Consumer Knitex (CMT Bangladesh) Ltd.

14 May 2014

Observations

Non-engineered structures

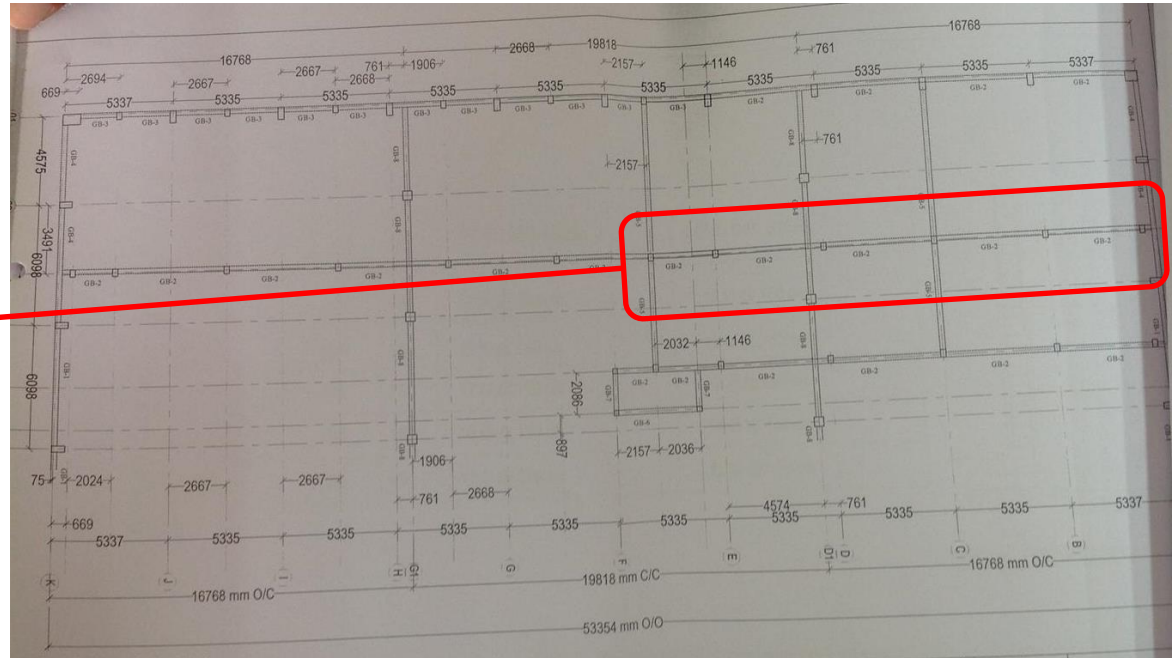
No drawings for the childcare building were presented and in general the structure appears to be non-engineered. The main issues observed were:

- Perimeter walls and columns acting as cantilevers, no foundation details presented.
- Overall stability of roof system not clear due to false ceiling.
- Adequacy of connection detail between roof truss and perimeter columns/walls.
- Section sizes used in roof system to be clarified.

Item No.	Observation	Recommended Action Plan	Recommended Timeline
1	Structural stability of childcare building and lookout post (located along southern perimeter)	Structural Engineer to survey existing childcare building and propose any strengthening/remedial works if necessary. As-built drawings for the structure to be produced.	6-months
2	Structural stability of childcare building and lookout post (located along southern perimeter)	Structural Engineer to survey the lookout post, in particular how the building structure is connected to the columns and propose any strengthening/remedial works if necessary.	6-months
3	Discrepancies between the Dye house built structure and design drawings.	Structural engineer to review existing structure and update the drawings to reflect as-built design.	6-months
4	Flexural cracking in Administration building	Building engineer to monitor cracking, should cracks increase in size or length, Engineer to undertake detailed checks of strength and capacity and propose remedial works if necessary.	6-months

Documentation discrepancies

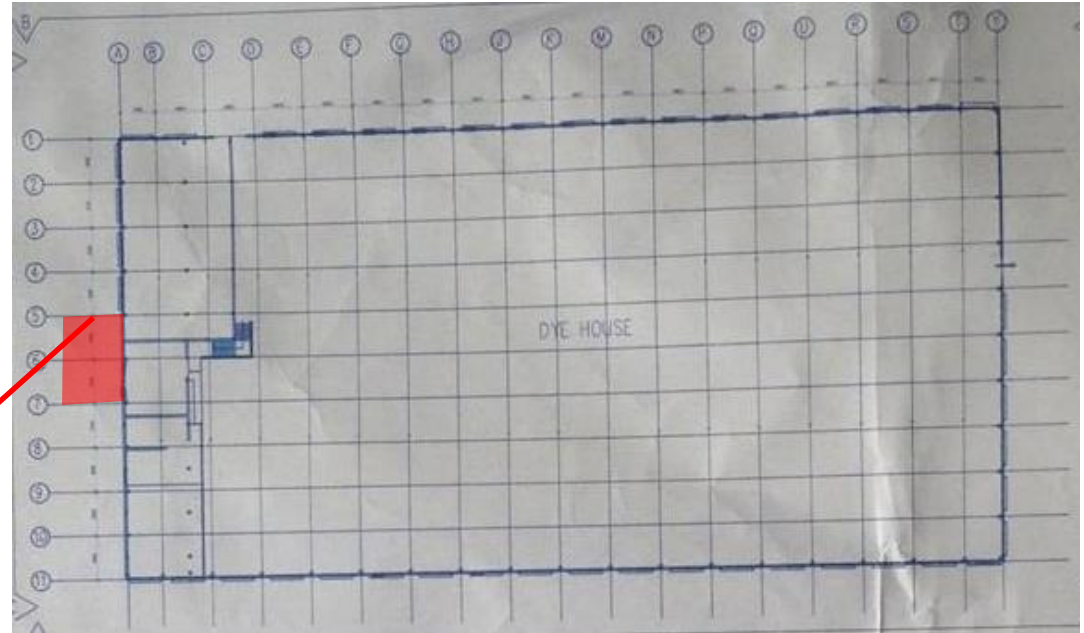
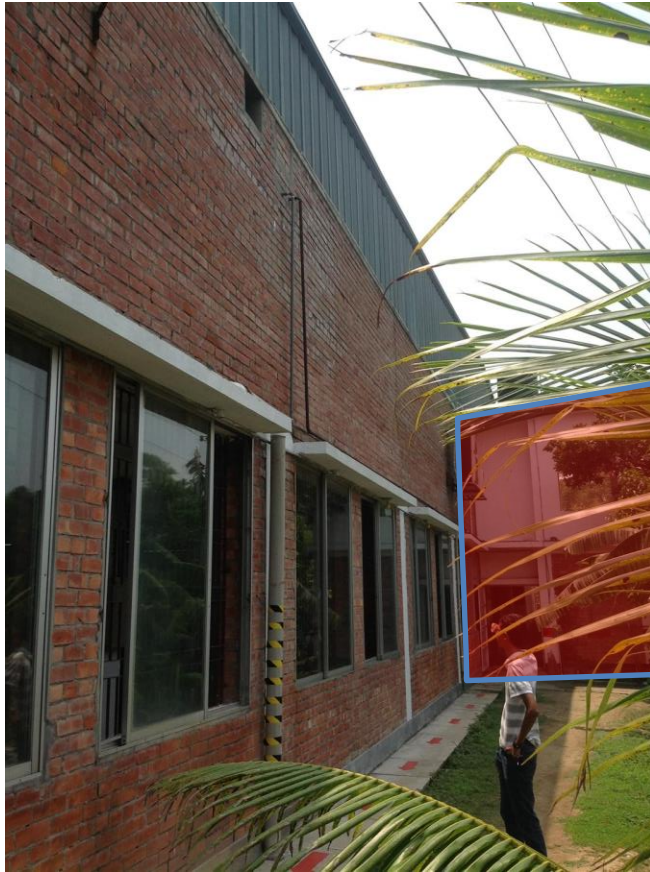
Inconsistencies observed between design drawings and what was constructed.

Additional line of beams and columns provided to mezzanine structure on south west side of building which were not shown on the structural drawings.

A toilet block was observed at the south west gable end of the dye house structure. This building was not present on either the structural or the permit drawings.

Flexural cracking in admin. building

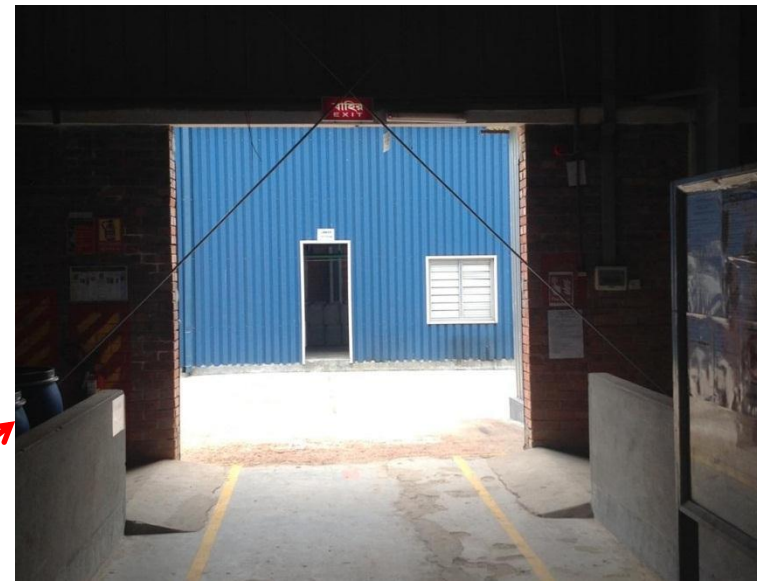
Hairline cracking was observed on the soffit of the roof slab and supporting beams in the administration building. The size and location of the cracks is consistent with flexural cracking.
